digital		ORIGINATOR Tom Orr 1.2		ECO NO. <u>M7254-0001</u>																					
ENGINEERING CHANGE ORDER <u>9167</u>		TEL EXT 2791 DATE 11/17/72		SHEET <u>1</u> OF <u>1</u>																					
		DISC PROJ NO E20-06734		DATE RECEIVED <u>11-30-72</u>																					
		COST CENTER NO. <u>378</u>		FIRST ISSUE <u>12-14-72</u>																					
				FINAL ISSUE <u>12-17-72</u>																					
PROBLEM				UNIT TO BE CHANGED																					
1) RK11-D samples word count overflow at sector end time to determine if a transfer is complete. This gives premature termination of write and write check functions during short sectors.				M7254																					
2) Temporary availability problems with T.I.7427 #19-10870				Etch																					
CORRECTION				Rev. C																					
1) Use file done signal from M7256 instead of word count overflow for sample at sector end.				DISC CODE 03																					
2) Add 8875 #19-10647 to parts list as an alternative to 7427.				OPTIONS AFFECTED																					
BREAK-IN/EFFECTIVITY				RK11-D,E																					
Rework all M7254 Rev C boards.				PRODUCT LINES AFFECTED																					
				PDP-11																					
IT

SIZE CODE: DCS
 NUMBER: M7254-0-1
 SHEET: 2 OF 2

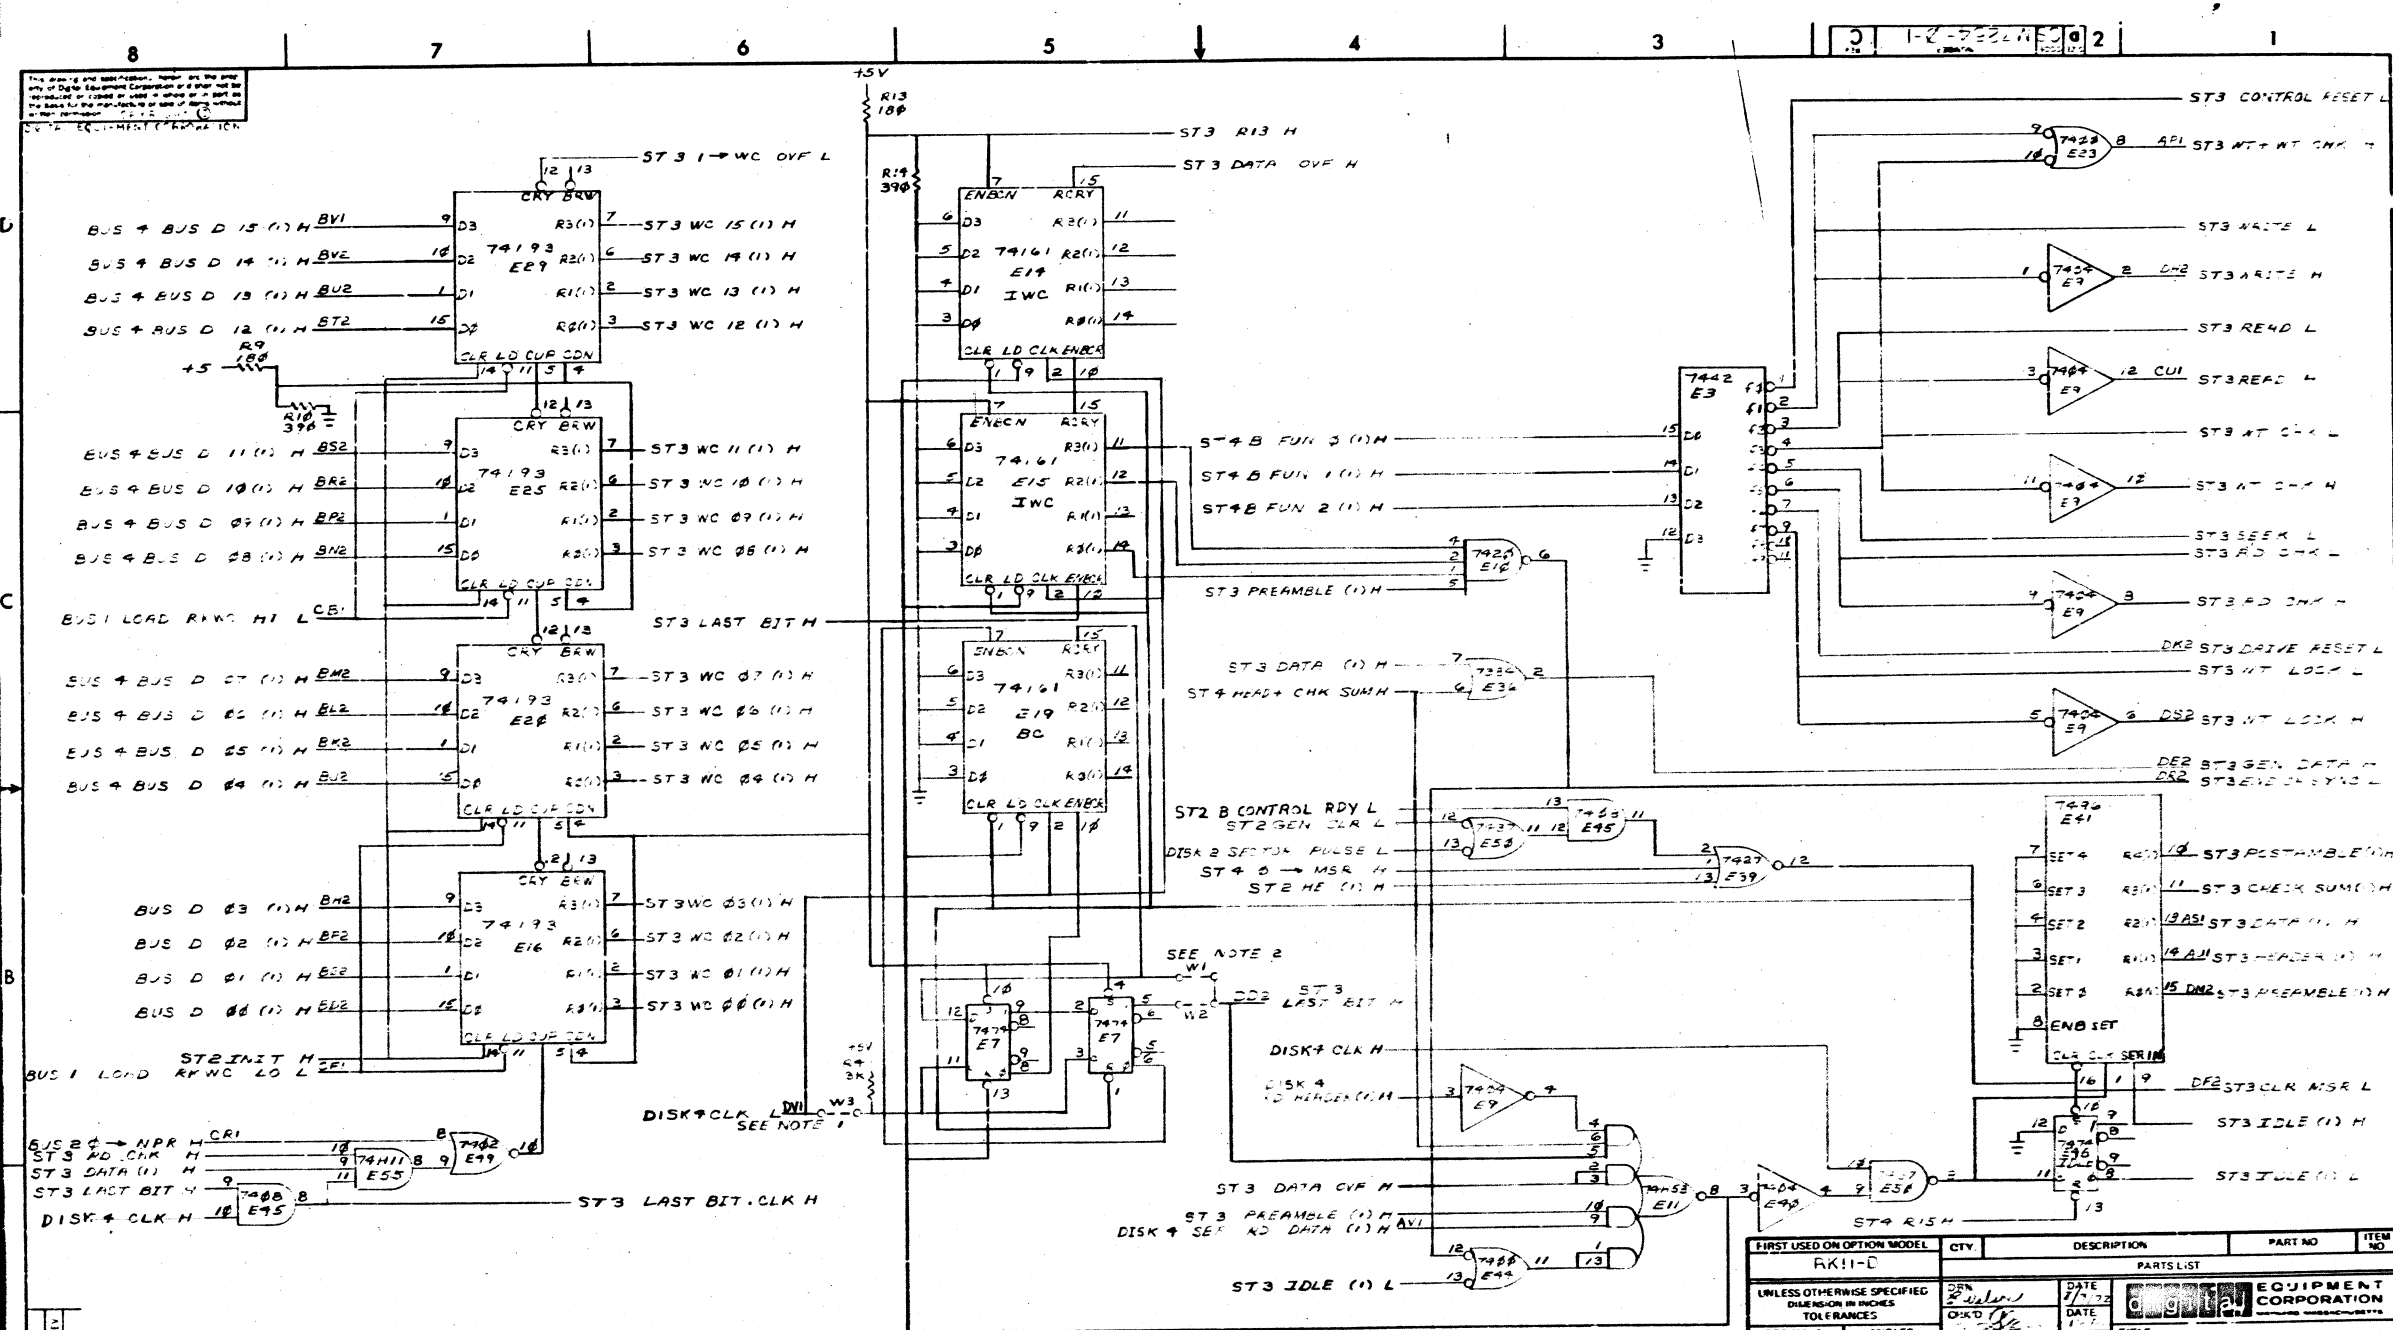
<table><tr> <th>ITEM NO.</th> <th>DOCUMENT/PART NO</th> <th>OLD REV</th> <th>NEW REV</th> <th>DESP CODE</th> <th>DESCRIPTION OF CHANGE</th> <th>FIELD SERVICE AFFECTED</th> </tr><tr> <td>7.</td> <td>5009905 Rework notes</td> <td>C</td> <td>C</td> <td>09</td> <td>Rework boards as shown below: 1. Delete C34, C36 and replace with 100 pf caps. 2. Add 1K RES as shown on AH drawing. 3. Make 3 etch cuts and add 3 wires as shown on AH drawing. </td> <td> <input type="checkbox"/> YES <input checked="" type="checkbox"/> NO TYPE OF CHANGE <input type="checkbox"/> ELECTRICAL <input type="checkbox"/> MECHANICAL <input checked="" type="checkbox"/> MODULE ORDER PR MODEL <input type="checkbox"/> YES <input checked="" type="checkbox"/> NO </td> </tr></table>

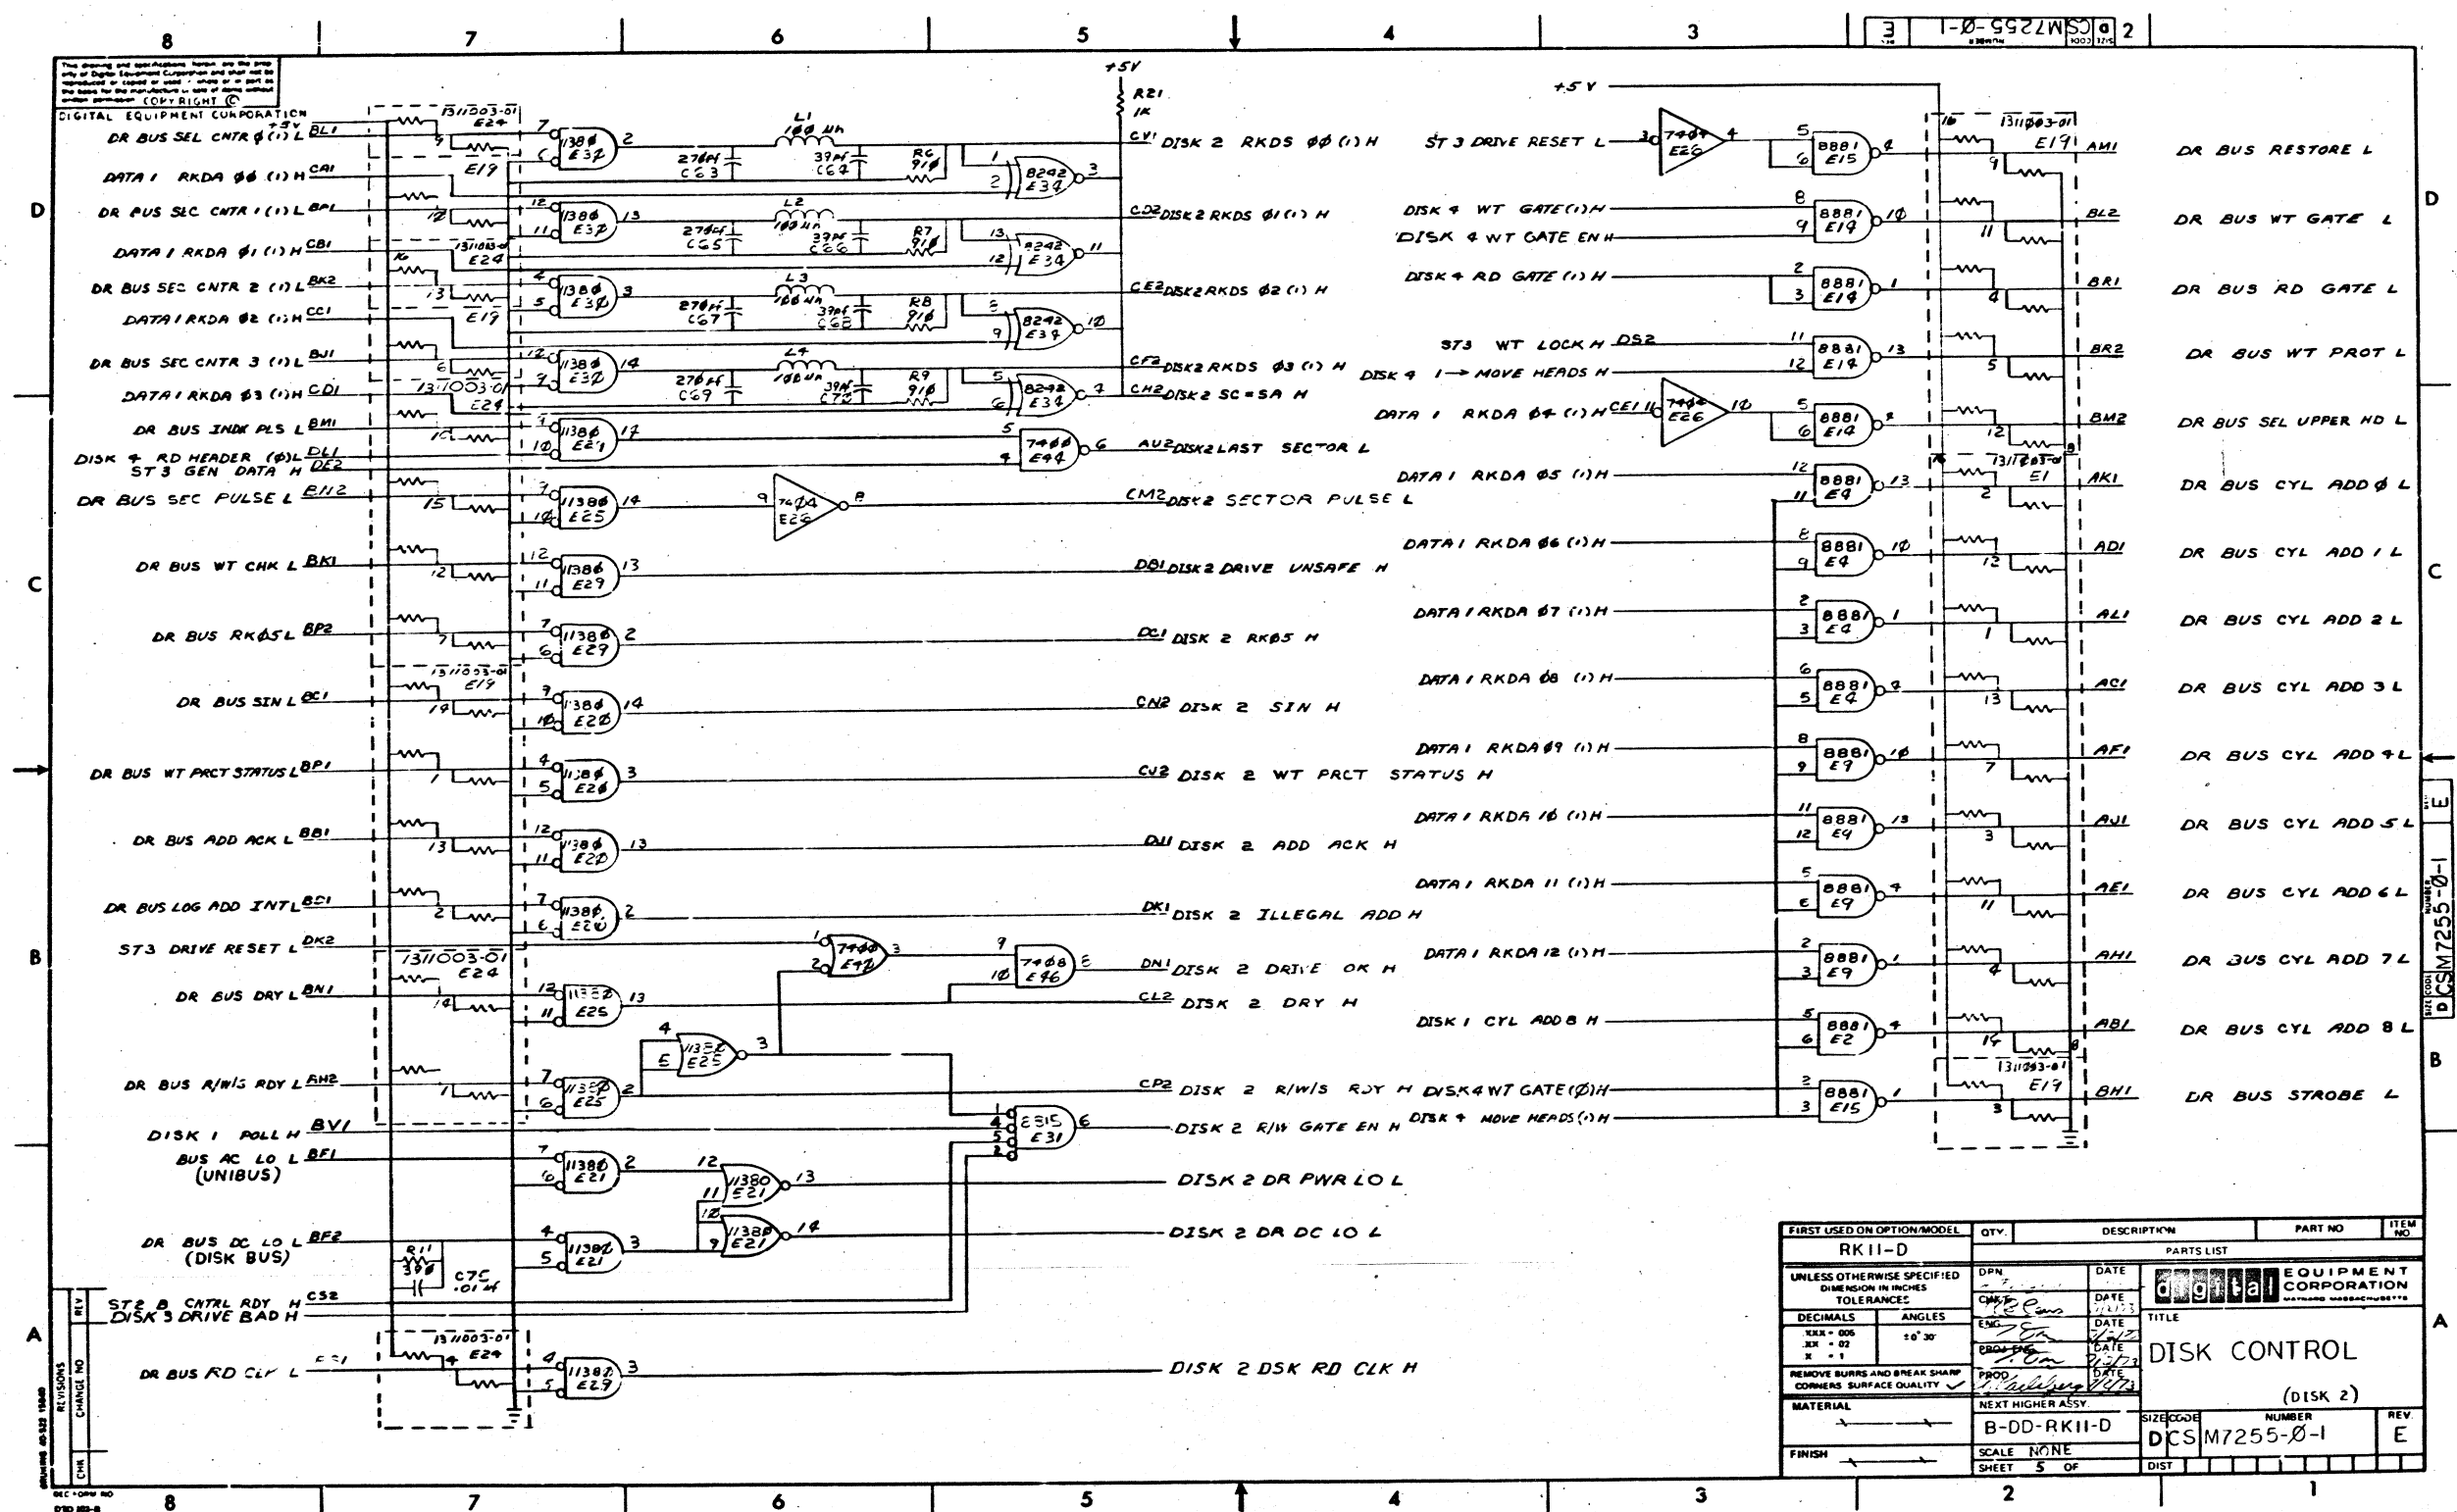
<table><tr> <th>ITEM NO.</th> <th>DOCUMENT/PART NO.</th> <th>OLD REV</th> <th>NEW REV</th> <th>DISP CODE</th> <th>DESCRIPTION OF CHANGE</th> </tr><tr> <td></td> <td>Sheet 5</td> <td>D</td> <td>E</td> <td>06</td> <td>Remove E32, R3 and C71 from Circuit Schematic.</td> </tr></table>

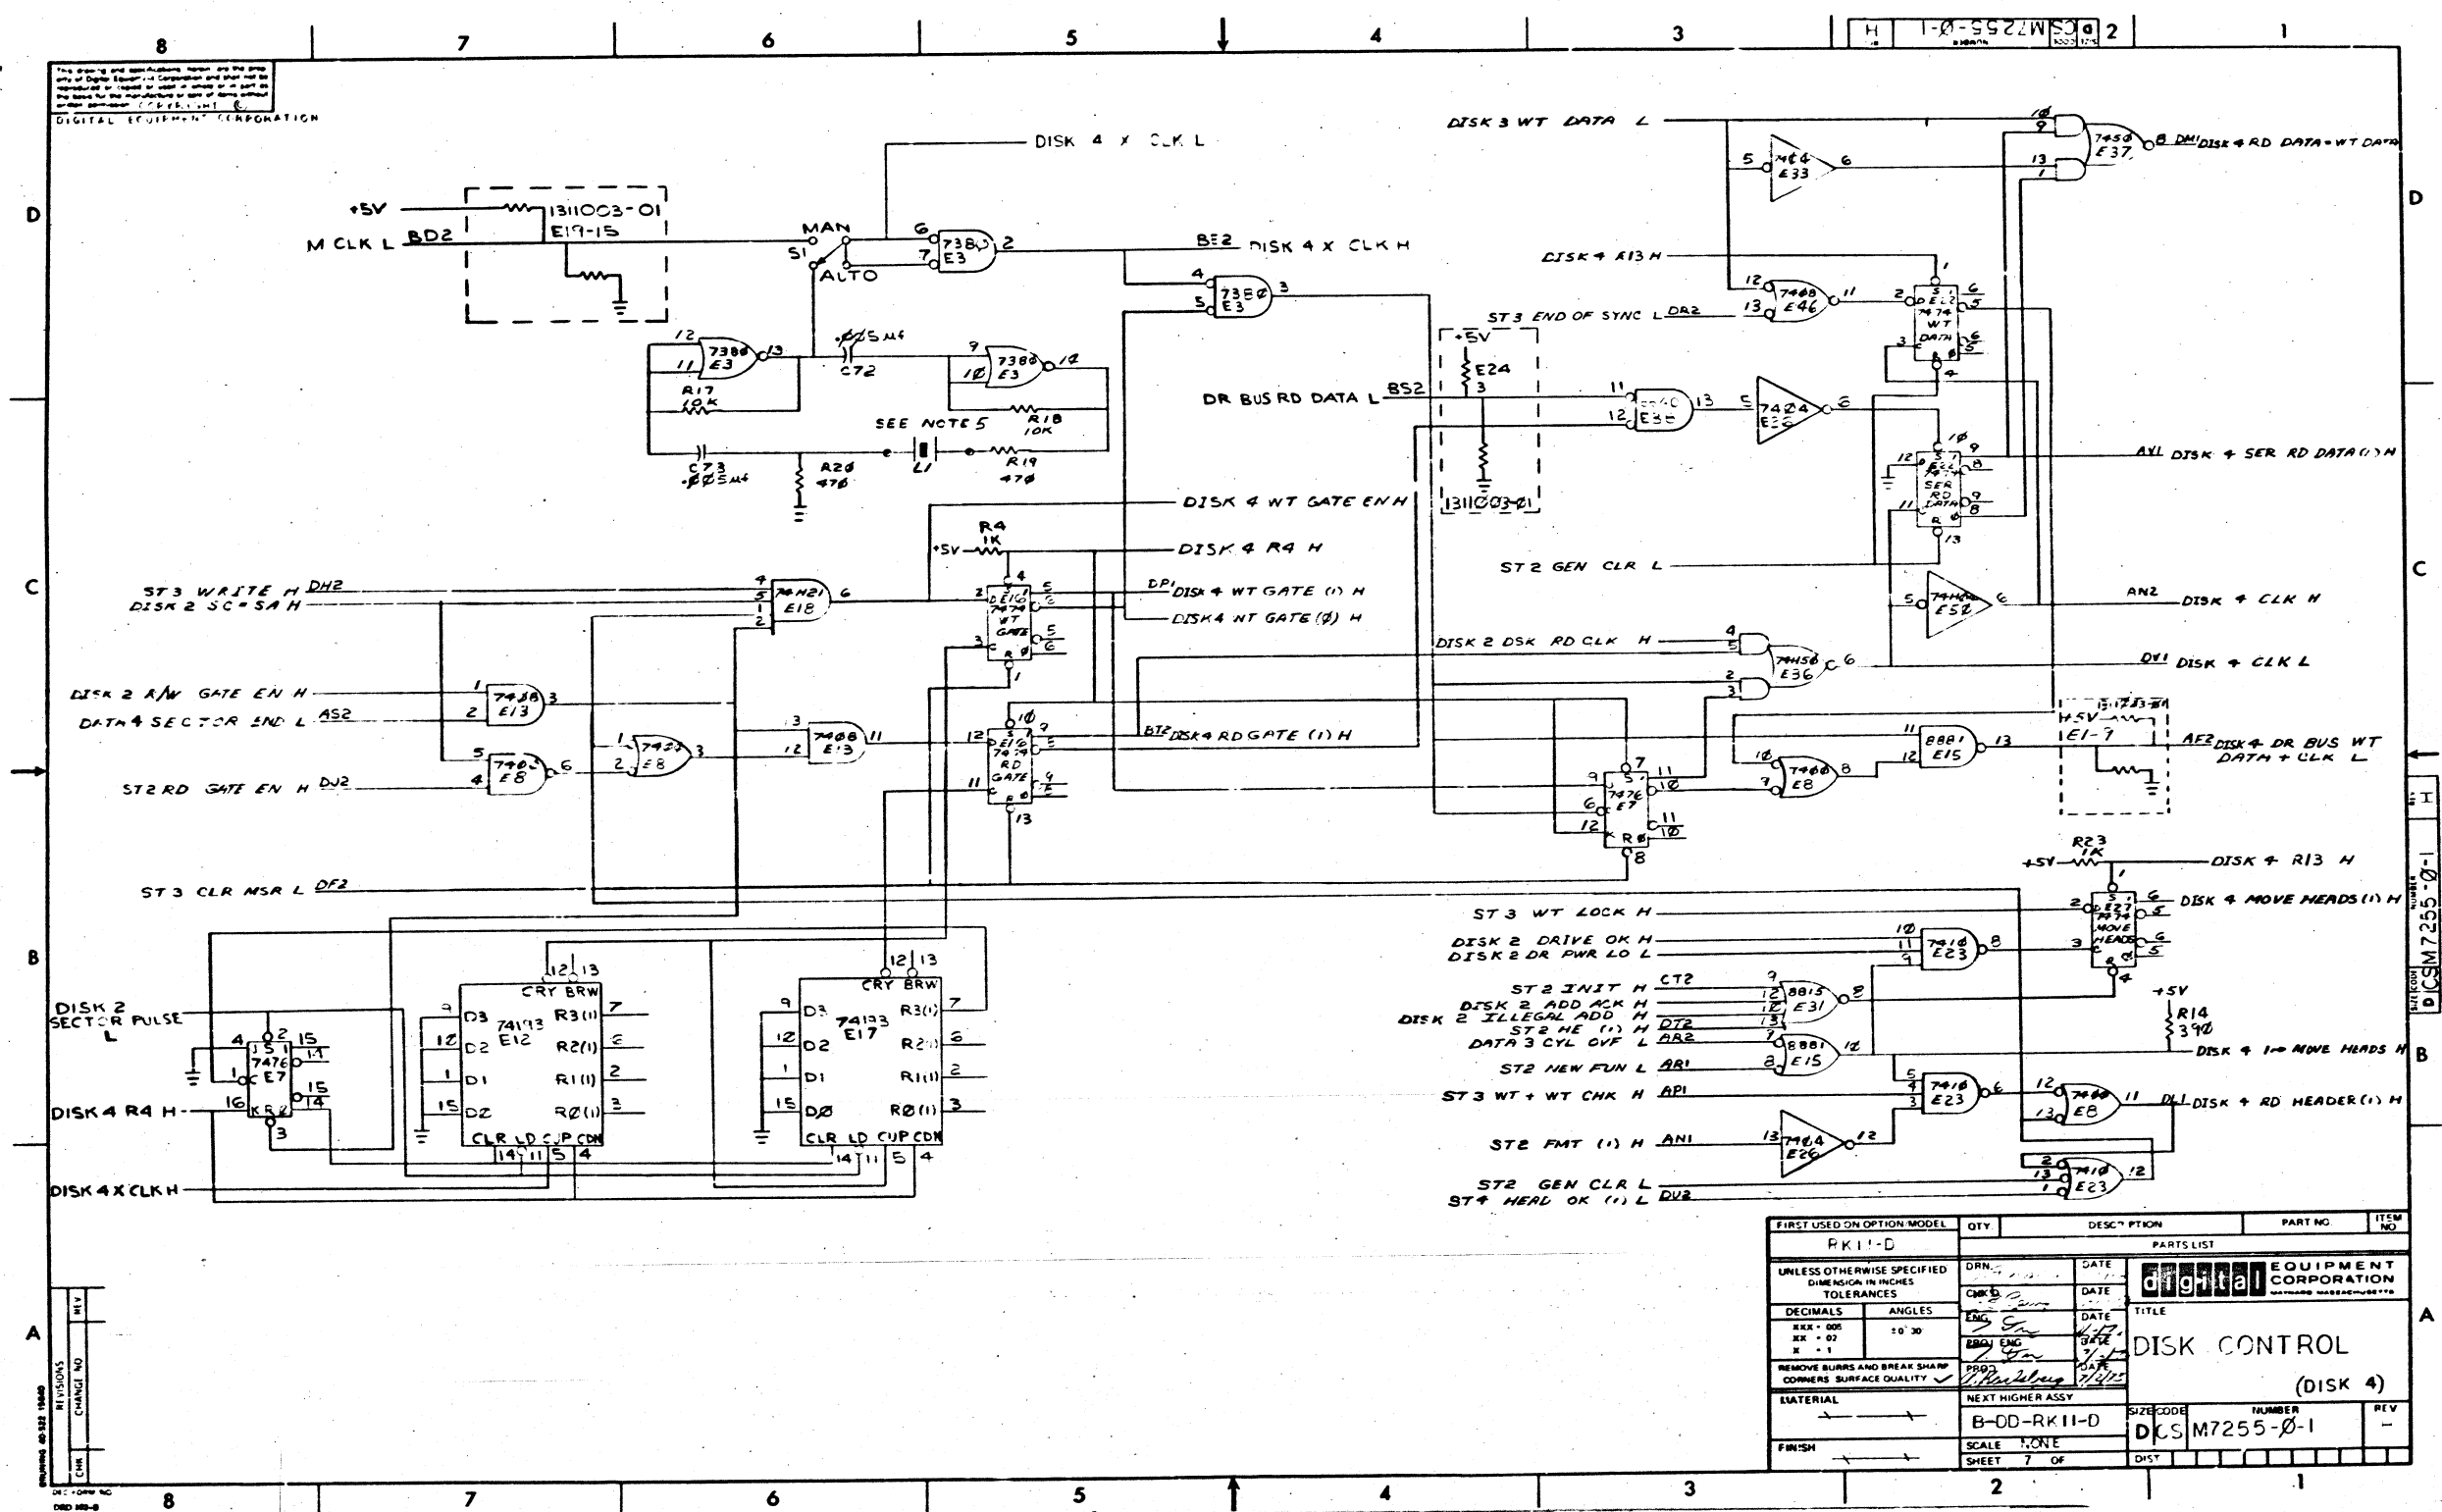
Sheet 5	E	F	06	Change all 11380 logic gates to 8640.	<input type="checkbox"/> FIELD SERVICE AFFECTED <input type="checkbox"/> YES <input checked="" type="checkbox"/> NO <input type="checkbox"/> Customer Charge <input type="checkbox"/> Product Line Change

Sheet 7	F	H	06	Change 11380 logic gate to 8640.	<input type="checkbox"/> TYPE OF CHANGE <input type="checkbox"/> ELECTRICAL <input type="checkbox"/> MECHANICAL <input checked="" type="checkbox"/> MODULE <input type="checkbox"/> ORDER PR MODEL <input type="checkbox"/> YES <input checked="" type="checkbox"/> NO
